# UNITED STATES PATENT AND TRADEMARK OFFICE

APPLICATION NO.	FILING DATE	FIRST NAMED INVENTOR	ATTORNEY DOCKET NO.	CONFIRMATION NO.
10/046,405	01/16/2002	Minoru Aoyama	2002_0008A	2075
513 7590 11/24/2003				
WENDEROTH, LIND & PONACK, L.L.P.				
2033 K STREET N. W.				
SUITE 800				
WASHINGTON, DC 20006-1021				
			EXAMINER	
			ALEJANDRO, RAYMOND	
			ART UNIT	PAPER NUMBER
			1745

<b>Office Action Summary</b>	<b>Application No.</b>	<b>Applicant(s)</b>	
	10/046,405	AOYAMA, MINORU	
	<b>Examiner</b>	<b>Art Unit</b>	
	Raymond Alejandro	1745

## DETAILED ACTION

Figures 1, 2, 3 above depict three layer component to be combined wherein the layers as combined are illustrated in Figure 4 above.

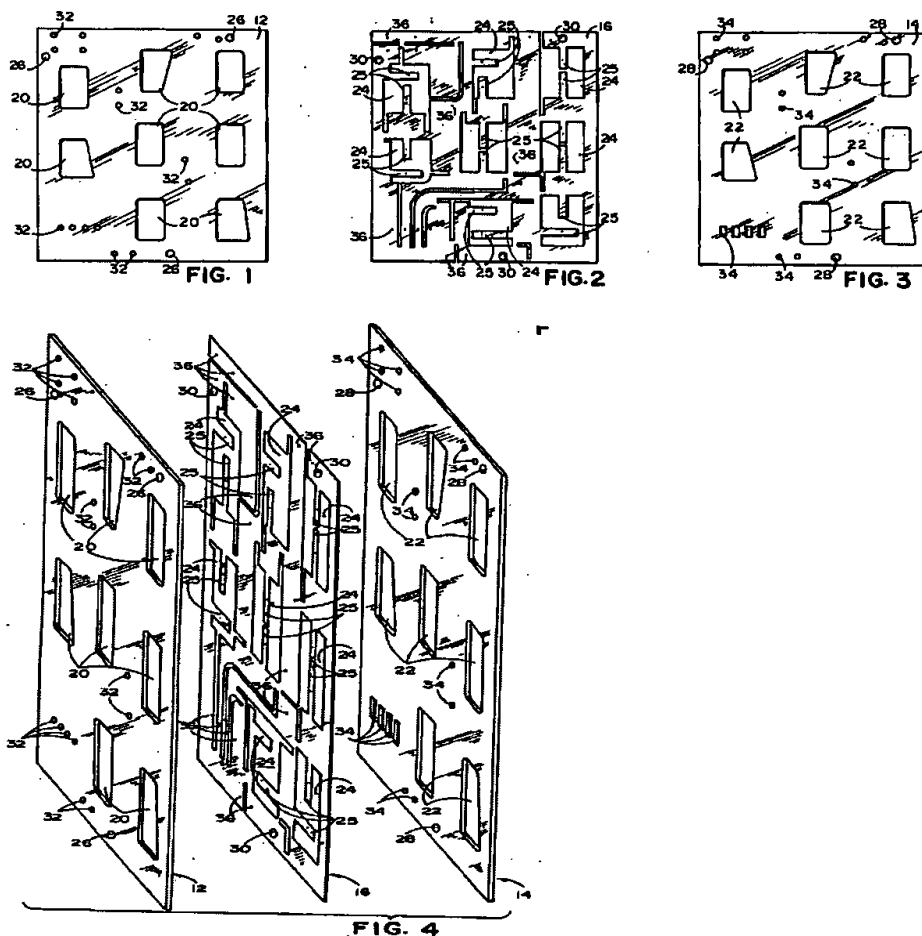
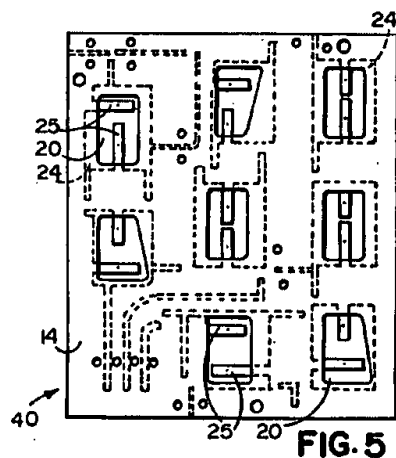
It is apparent from Figures 1-4 that clearance openings 20 are of a size and configuration to fit over the top of the terminals of a series of galvanic cells or batteries, in this case eight in number. Thus, there are eight openings 20 generally rectangular in configuration and large enough to extend around the periphery of the two terminals, positive and negative, of each battery (COL 2, line 67 to COL 3, line 5). Openings 22 in the upper insulation sheet 14 and opening 24 in the intermediate metal foil layer 16 are provided corresponding in number and location to openings 20 in the lower insulation sheet 12 (COL 3, lines 41-45).

*Therefore, the eight openings 20, 22, 24 in respective sheets 12, 14 and 16 hold the battery cells. It is also noted that one of either the lower insulation sheet 12 or the upper insulation sheet 16 provides a configuration to hold or retain cells, thus, they act as the holding plate for holding the cells. Hence, the examiner has interpreted that one of the two insulation sheets serves as a holding plate per se. In addition, a common circuit board is positioned adjacent the cell terminals, wherein a lead element is connected to each terminal and to a portion of the circuit board.*

The plurality of cells are arranged in a pattern or grouping such that when the circuit board is placed thereon, each pair of tabs 25 overlies the respective negative and positive terminals or posts of the battery adjacent thereto as illustratively depicted in Figure 8 above. *It is apparent from Figures 2 and 4 that the positive lead plates and negative lead of at least two (2) adjacent cells are arranged alternatively as positive lead plates and negative lead plates.*

**FIG. 2**

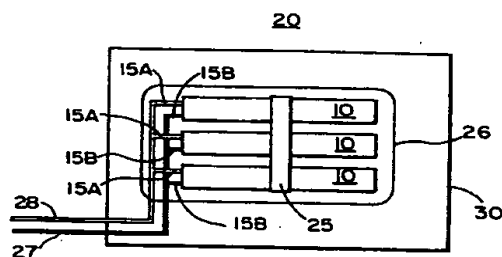
Hope et al disclose a battery packaging construction for multiple cell alkali metal batteries comprising a plurality of flat battery cells, which have leads extending therefrom (ABSTRACT). ***Figure 2*** below shows a battery which is constructed of a plurality of cells 10 with leads 15A and 15B (COL 3, lines 7-12/ COL 2, lines 56-58). *It is apparent from Figure 2 that the leads 15A and 15B extend from the battery surface in a parallel arrangement.*

In view of the above, it would have been obvious to one skilled in the art at the time the invention was made to make the specific lead plate configuration of Hope et al in the assembled battery of Stoklosa et al as Hope et al teach that leads extending from the single cell allow the single cell itself to have the leads electrically connected in series or parallel to terminals. Thus, the specific lead plate configuration as claimed would provide a battery package construction exhibiting satisfactory electrical connection and electrically connecting leads from the multiple cells to an external electrical current carrying member of the battery so that generated electrical energy be drawn and directed to an energy powered device. *Additionally, it has been held that changes in shape are obvious In re Dailey 149 USPQ 47 (CCPA 1966).*
